SMULDERS	EWP G1 External work platform – FAT documentation	25220 Hollandse Kust Zuid
---	---	------------------------------

1. FAT mechanical
 - Final release note
 - Punch list
2. FAT electrical
 - Final release note
 - Punch list
3. FAT coating
 - Final release note
 - Punch list
4. Overview NCR's and TQ's

Mechanical Release Note EWP Rev 2 #19

Punchlist mechanical

#1382 - Sharp edges

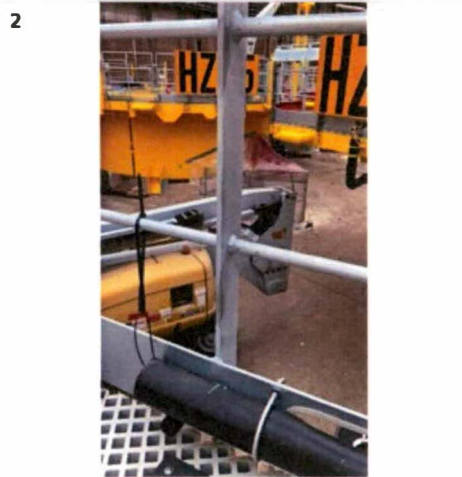
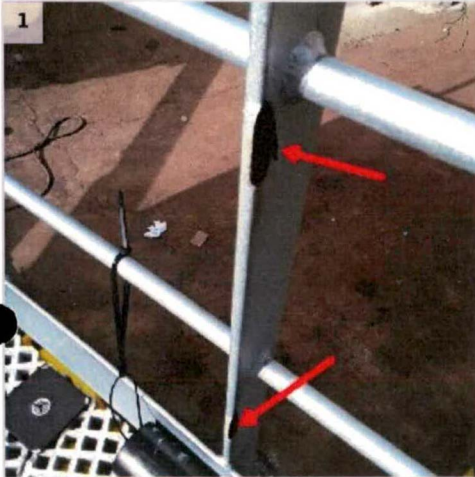
Ben Herygers Photo 1
Ben Herygers Sharp edges @Mechanical @kevin_kempis #client
Jens Daelemans Photo 2

● #1400 - To big gap on the finger guide

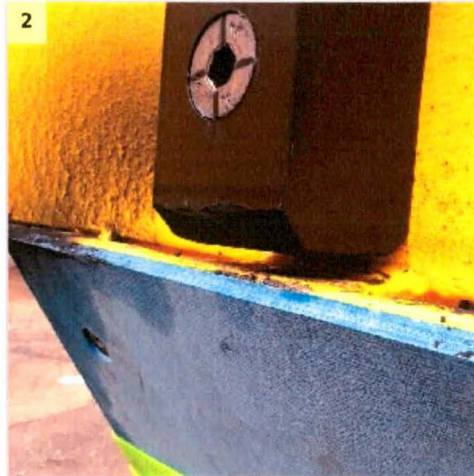
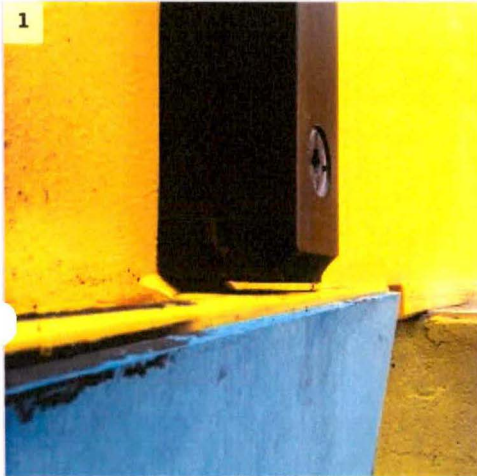
Ben Herygers	Photo 1	26 Jun 08:06
Ben Herygers	Photo 2	26 Jun 08:07
Ben Herygers	To big gap on the finger guide @Mechanical #client @kevin_kemps	26 Jun 08:07

● #1401 - Needs better chamfer

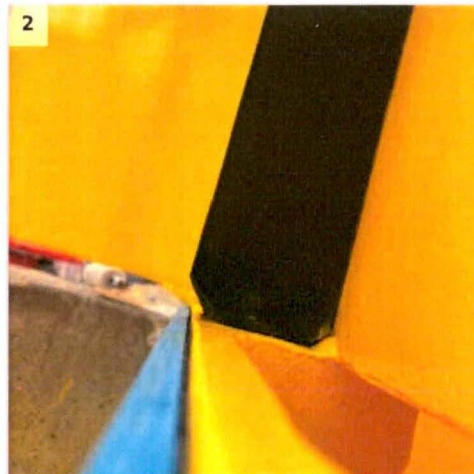
Ben Herygers	Photo 1	26 Jun 08:07
Ben Herygers	Needs better chamfer @Mechanical @kevin_kemps #client	26 Jun 08:08
Marcin Witkowski	Photo 2	29 Jun 13:31

● #1402 - Plate needs more adjustment (better in the middle)

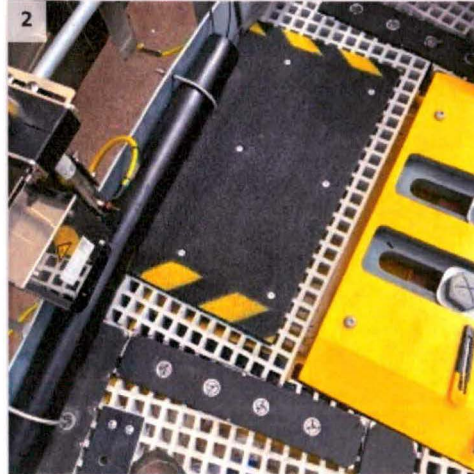
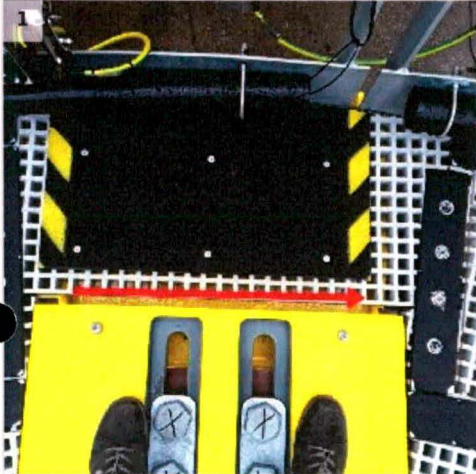
Ben Herygers	Photo 1	26 Jun 08:15
Ben Herygers	Plate needs more adjustment (better in the middle) @Mechanical @kevin_kemps #client	26 Jun 08:16
Marcin Witkowski	Photo 2	29 Jun 12:05

● #1403 - Coating missing

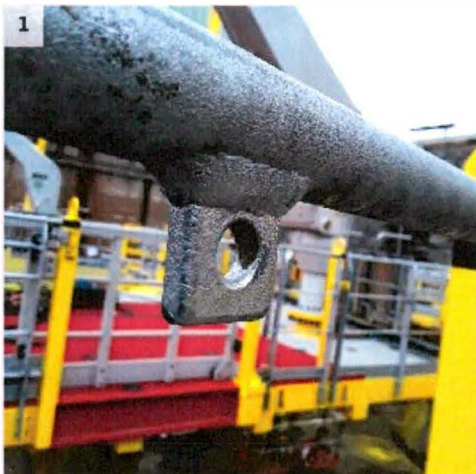
Ben Herygers	Photo 1	26 Jun 08:25
Ben Herygers	Photo 2	26 Jun 08:25
Ben Herygers	Photo 3	26 Jun 08:25
Ben Herygers	Coating missing @TouchUp @ilchan_chanko #client	26 Jun 08:26
Ilchan Chanko	Photo 4	28 Jun 11:41
Ilchan Chanko	Photo 5	28 Jun 11:41

● #1404 - Video missing for the double gate

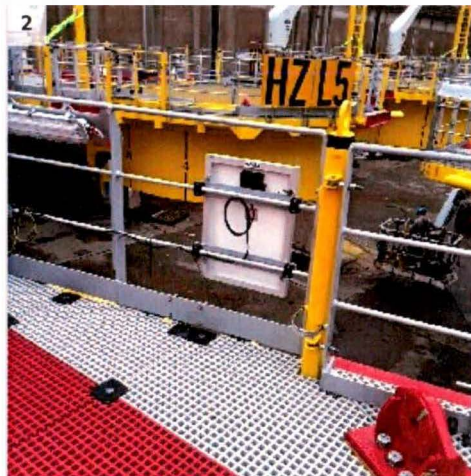
Ben Herygers	Photo 1	
Ben Herygers	Photo 2	
Ben Herygers	Video missing for the double gate	@Mechanical @dawid_kaminski @kevin_kemps #client
Ben Herygers	For opening from the gate	
Marcin Witkowski	Check task #1509

H3M3		Rev. 2	Date: 29.06.2021

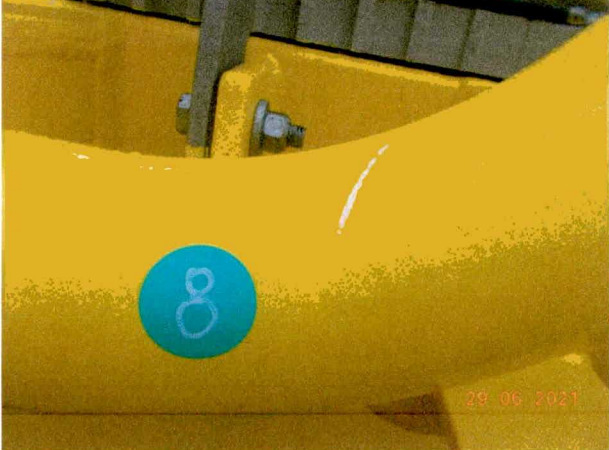
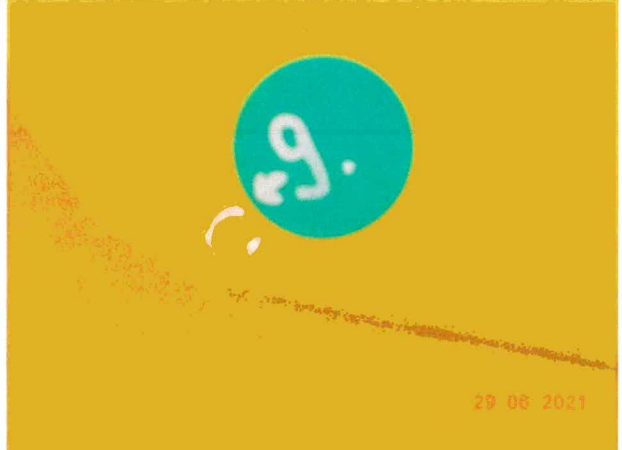
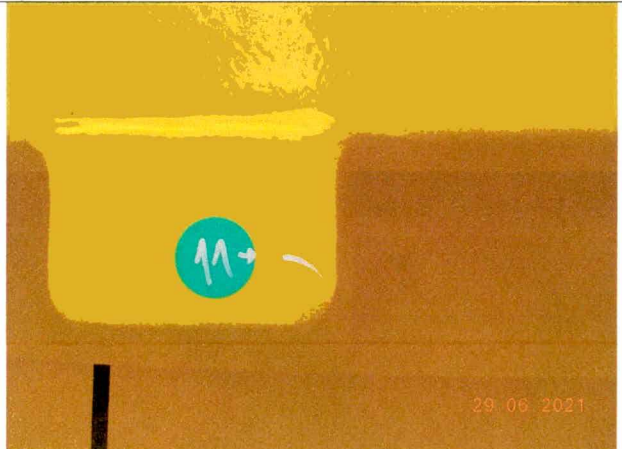
No. 7 – HDG railings, touch up rework required.		No. 8 – Fly rust and tape residue, cleaning required.

No. 9 – Mechanical damage to coating.		No. 10 – Full coat system must be applied 20 mm up face of plate. See drawing 8522.

No. 11 – Mechanical damage to coating.		No. 12 – Full coat system must be applied 20 mm up face of plate. See drawing 8522.
